Collapsible Aluminum Household Effects Shipping Container

"EVALUATION OF AN EXPERIMENTAL COLLAPSIBLE
ALUMINUM HOUSEHOLD EFFECTS CONTAINER"

ADDENDUM TO EVALUATION OF AN EXPERIMENTAL
COLLAPSIBLE ALUMINUM HOUSEHOLD EFFECTS CONTAINER

DWG. NO. - SED-SK-335

ASSEMBLED UNIT

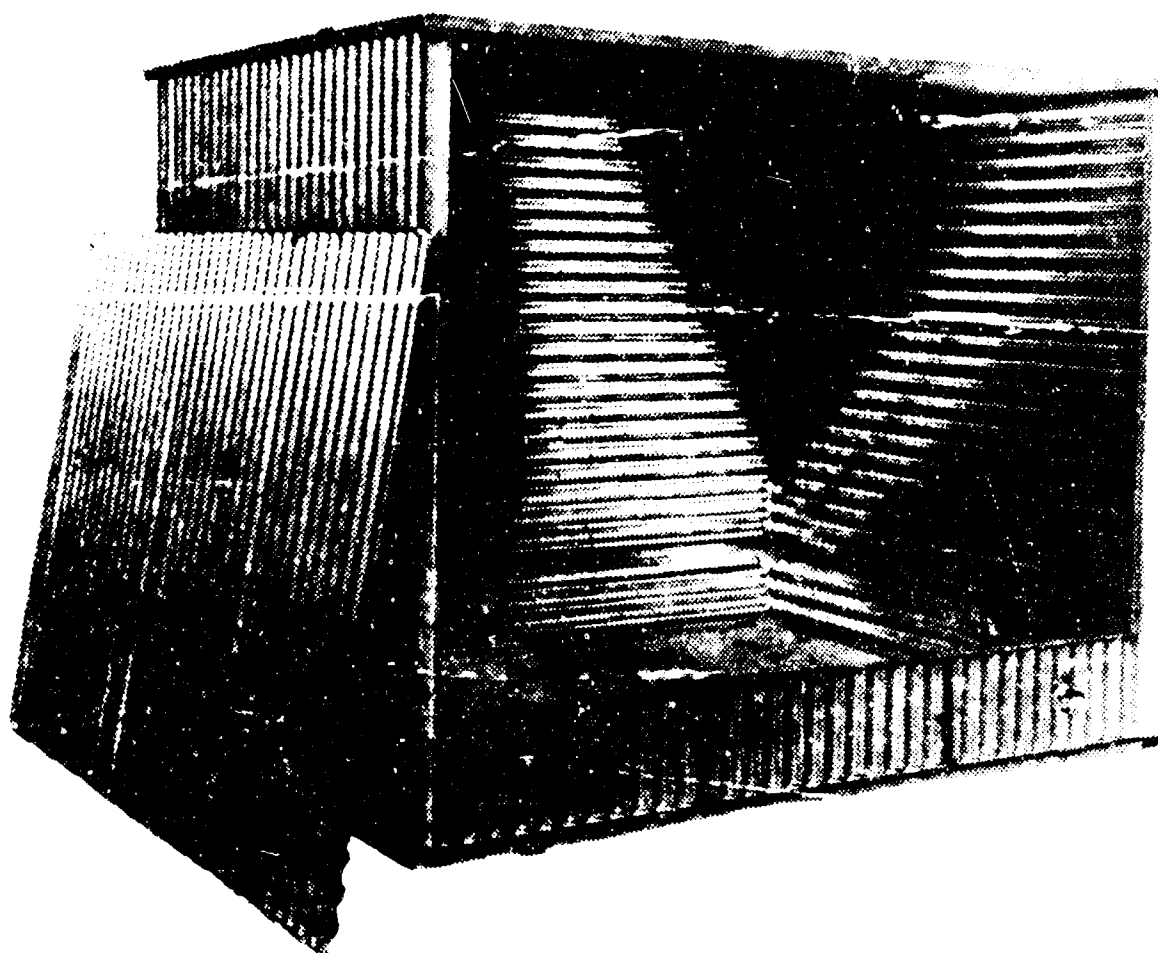
Initial assembly of the Collapsible Aluminum Household Effects Container disclosed that five bolt holes did not line up. These holes

were enlarged in order that the container could be fully assembled. Bolting the upper and lower side panels together was awkward and time consuming due to the small clearance around the bolt heads. These bolts are located between the aluminum corrugations and it is necessary to use 9/16" box wrenches to effectively turn them. Even then, the bolts can only be turned less than 90 degrees at one time.

The weather resistance test disclosed that a small amount of water seeped in between the horizontal angles connecting the upper and lower side panels. This condition is undesirable if the loaded container is to be exposed to the elements for any practical length of time.

The roof design of the container is such that it precludes tiering of the containers, one on another, or placing of heavy loads on the roof.

If it is anticipated that the containers will be exposed to the elements for appreciable lengths of time, it is recommended that a thin gasket be secured to the lower framing angle of the upper side panels. This will provide a tight horizontal joint between side panels, and eliminate water from entering along that joint. If, however, the

ONE RUN OF DRILLED
BOLT HOLES ELONGATED,
ON ONE SIDE OF ALL
BOLTED JOINTS

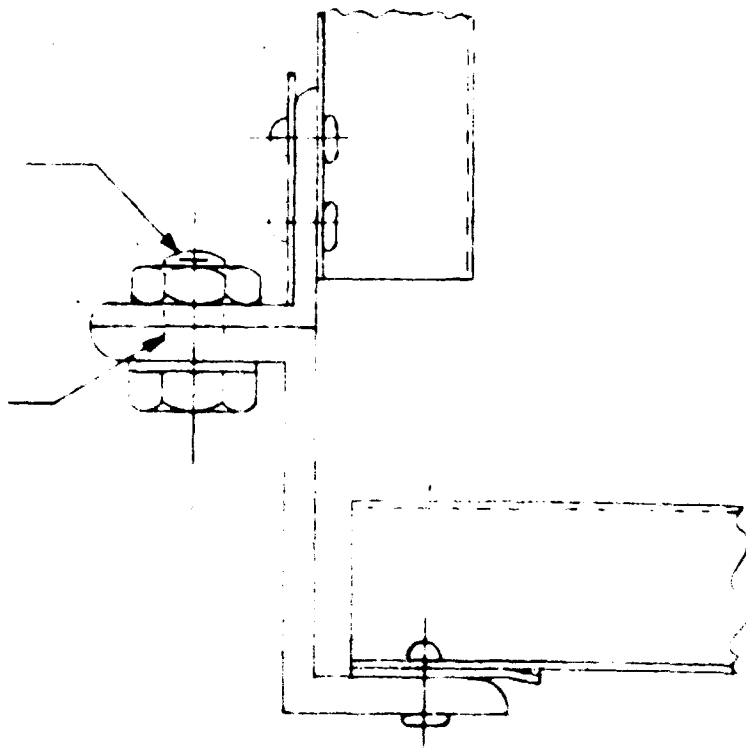
Bolting size was increased from $3/8"$ - 16 NC to $7/16"$ - 14 NC to accommodate requests for stronger bolting. Some reports stated that threads stripped under load when closing container. Evidently the mating surfaces were drawn together and one or two

turns taken by hand on the bolts, and upon releasing the load the threads stripped. This condition was probably aggravated by the fact that the bolting was not as originally specified, 3/8" - 24 NF being furnished instead of 3/8" - 16 NC, in which case each individual bolt thread was weaker.

2. A .064 aluminum plaque 18" x 24" placed on one long panel to permit marking with shipping identification and codes.
3. Bolt specifications changed to 7/16" - 14 NC for increased strength, and one hole per fastening elongated to allow for inaccuracies in drilling.

ALUMINUM IDENTIFICATION
PLAQUE .064" X 18" X 24"

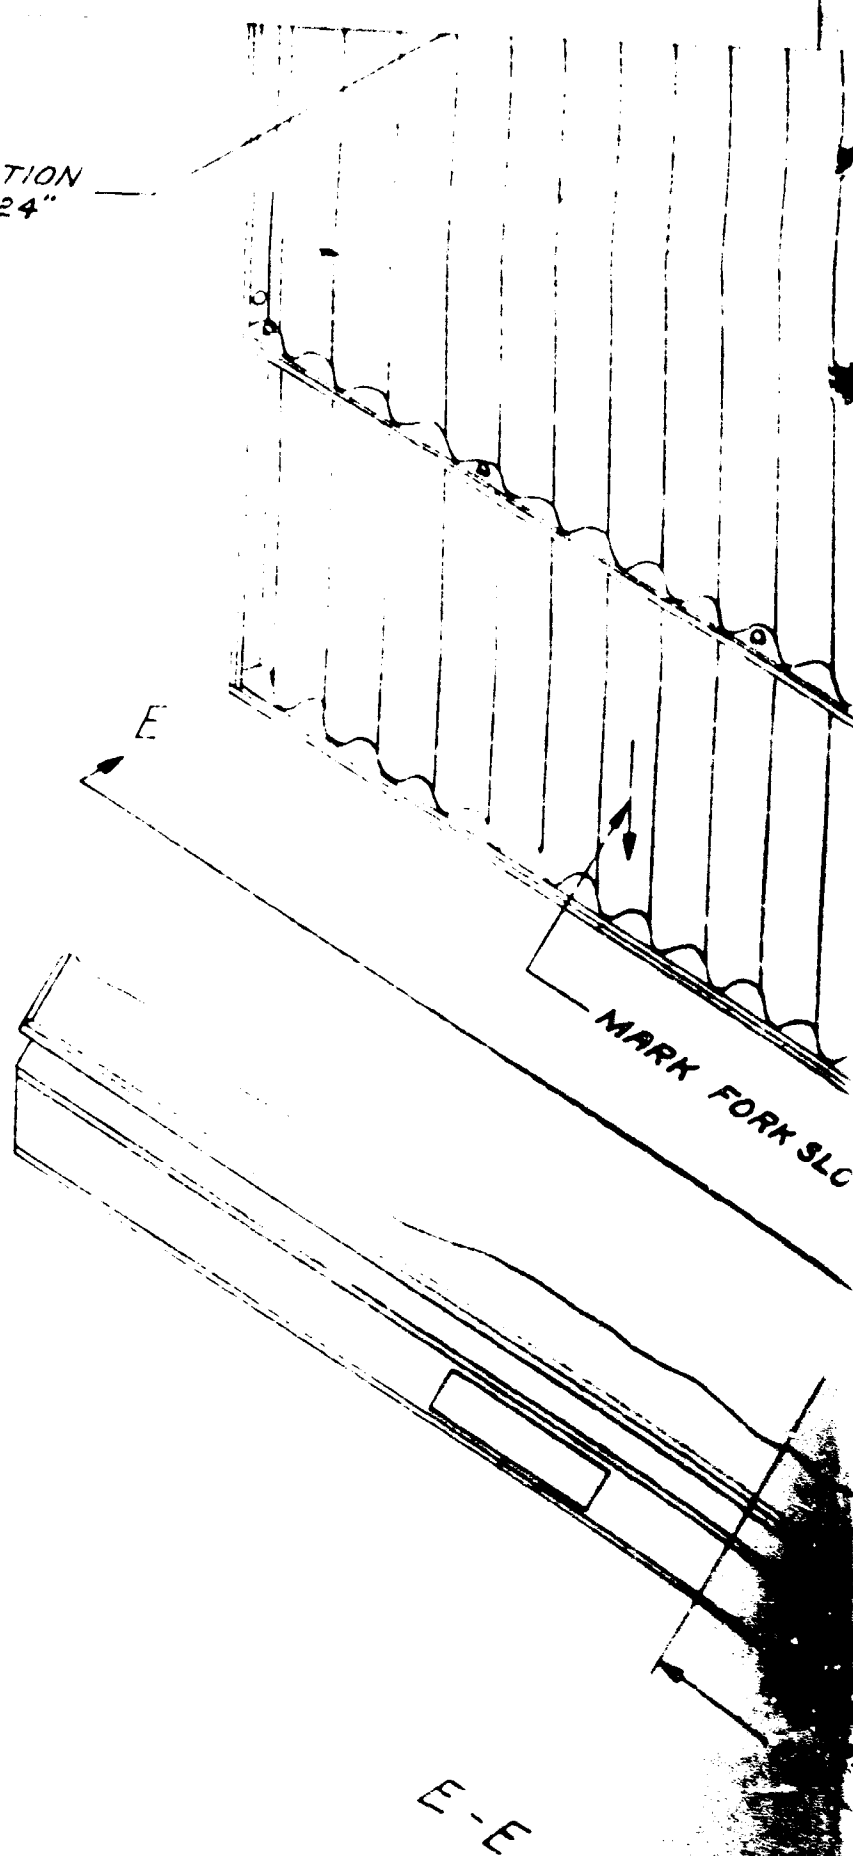
The marking plaque should also assist in indicating the front for loading and unloading.

1024 X 33 X 72 ALUM. I.B.M.
SCUFF PLATE BETWEEN
BEARING PLATES
3/6" DIA. R.H. RIVET
535-T61

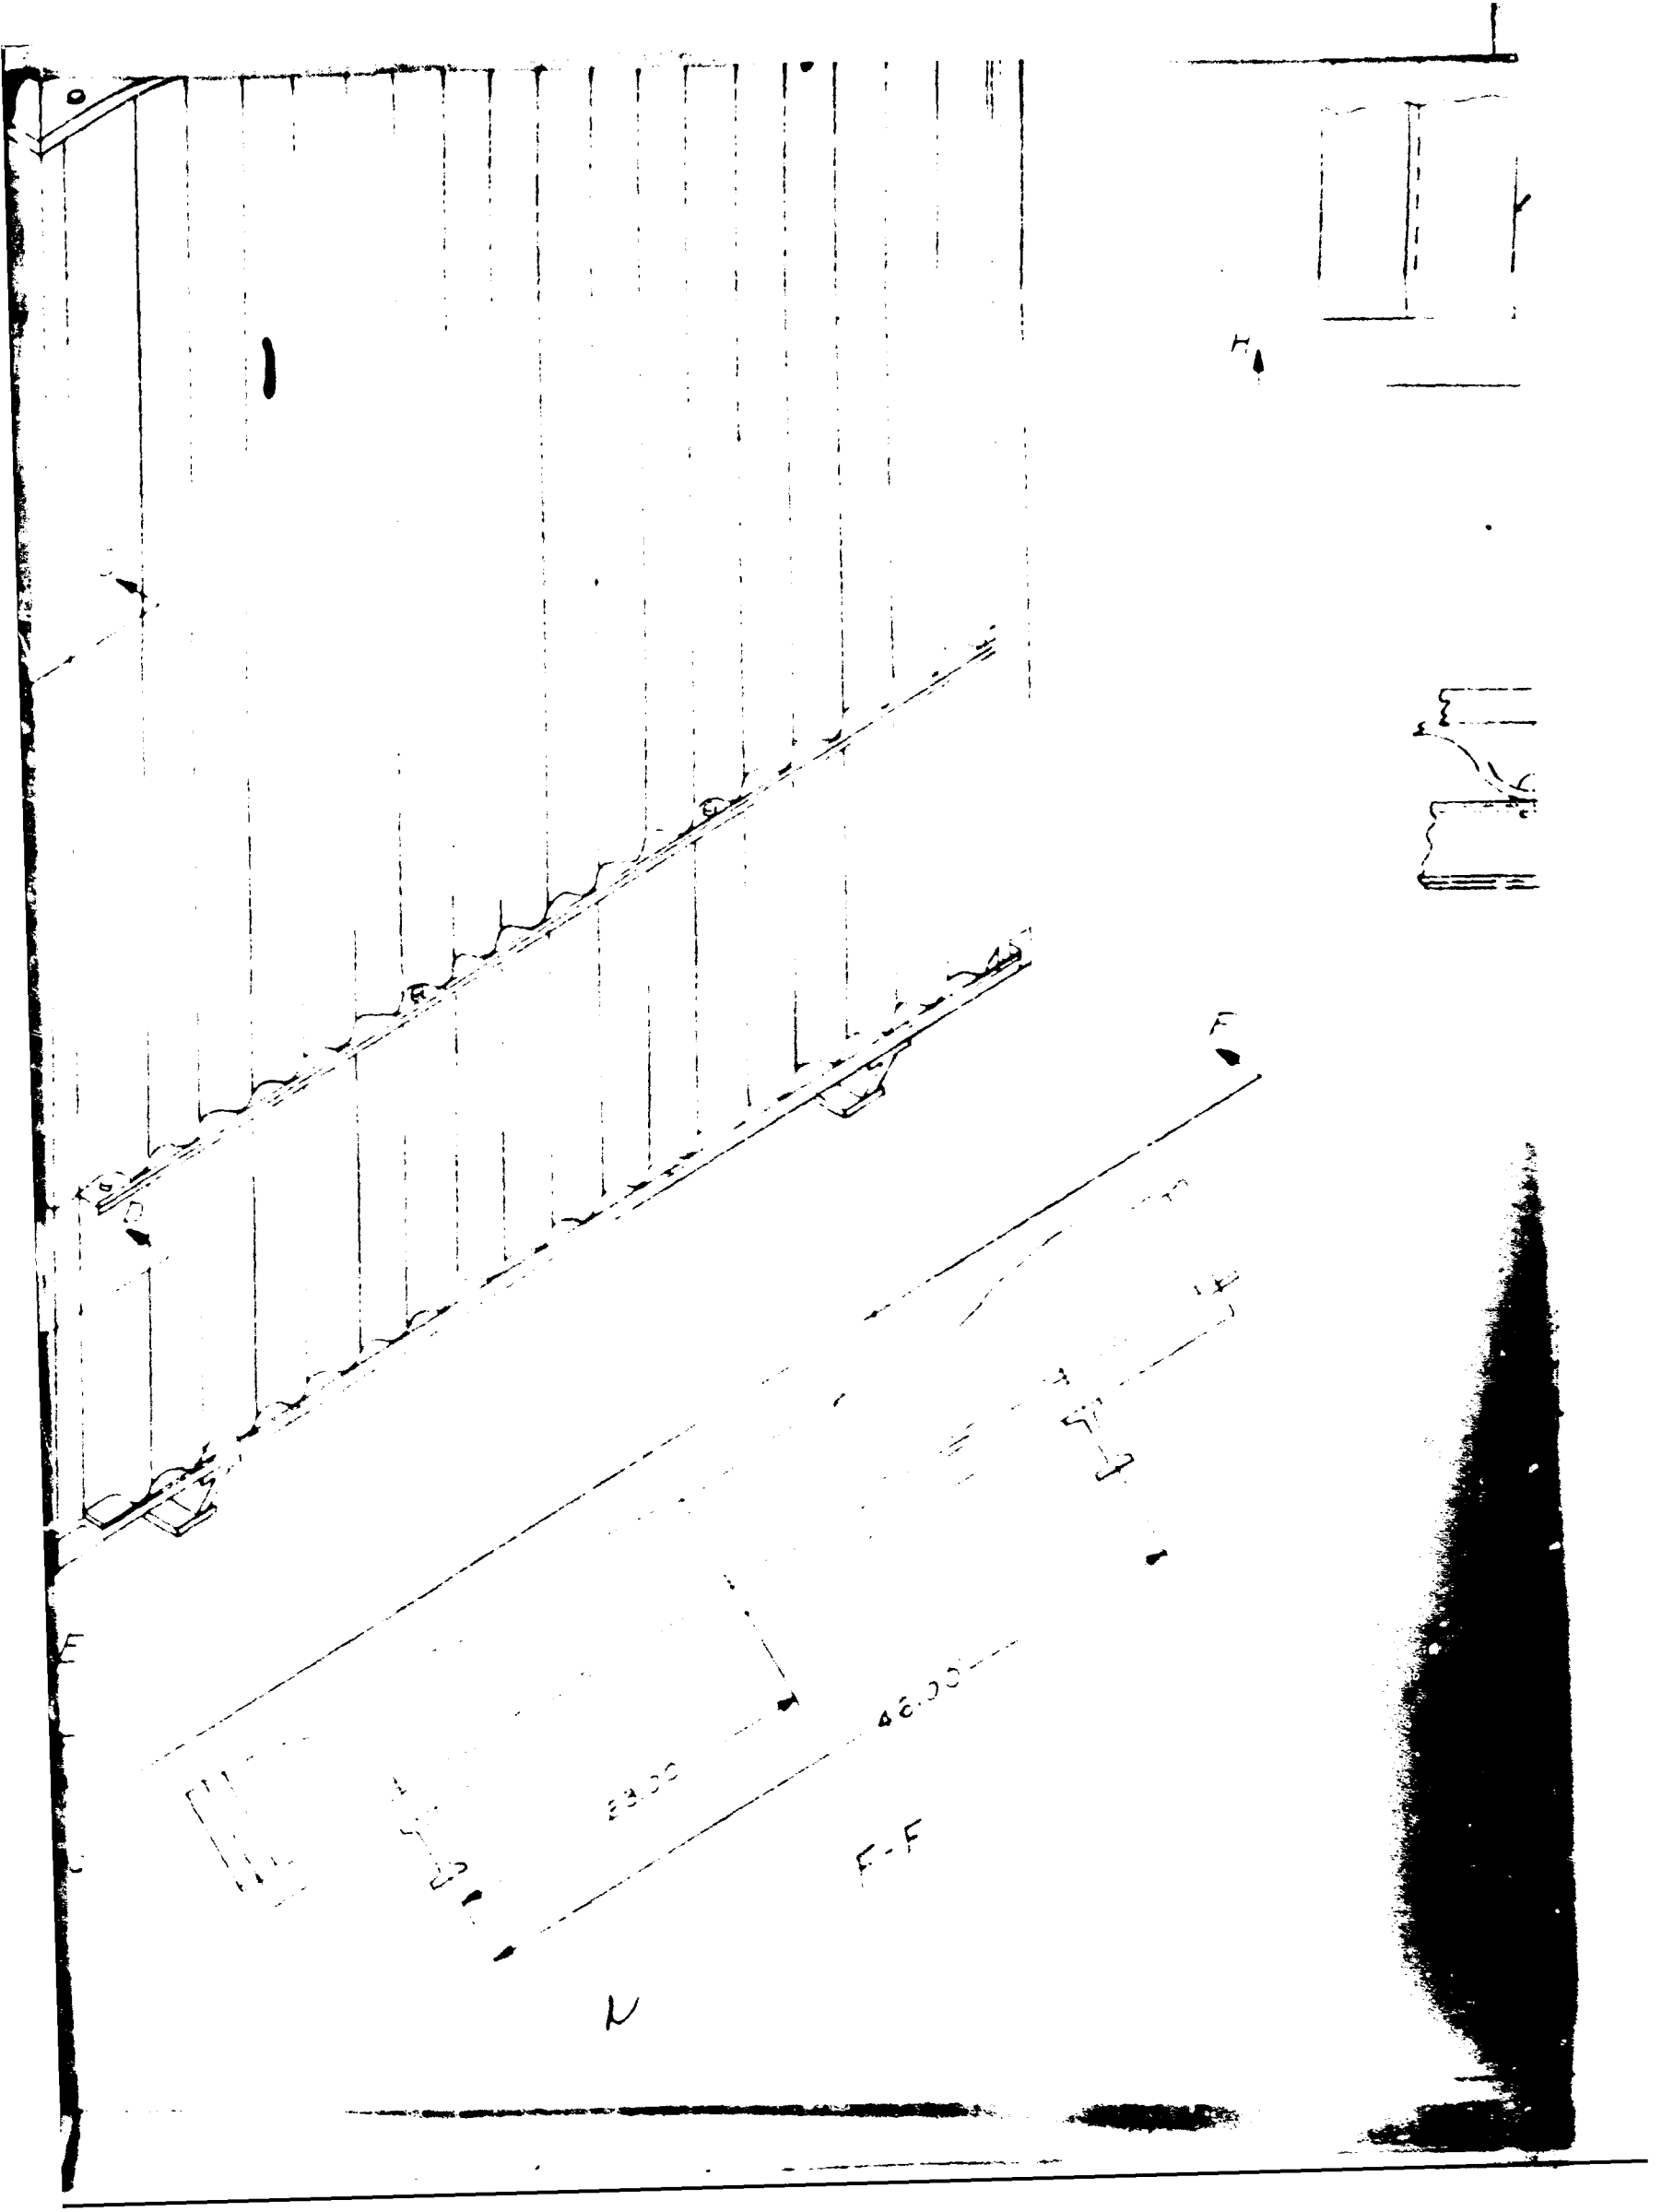
The .064" sheet under the bottom between the skids was considered necessary for protection against scuffing. Several pictures were furnished by using facilities showing gouging and scuffing from forks. It was noted in the laboratory test container that fifteen rivets in the bottom had failed around the corners. This occurred because the I beam skids were cut $1\frac{1}{4}$ inches too short on each end, and therefore did not support the Z beam frame around the bottom. This was a deviation from the drawing, which called for the skids to be brought out right to the edge of the container and therefore supporting the Z beam and the entire panel load.

1. An .062 aluminum sheet between the I beam skins and against the bottom corrugation for protection against fork truck forks.
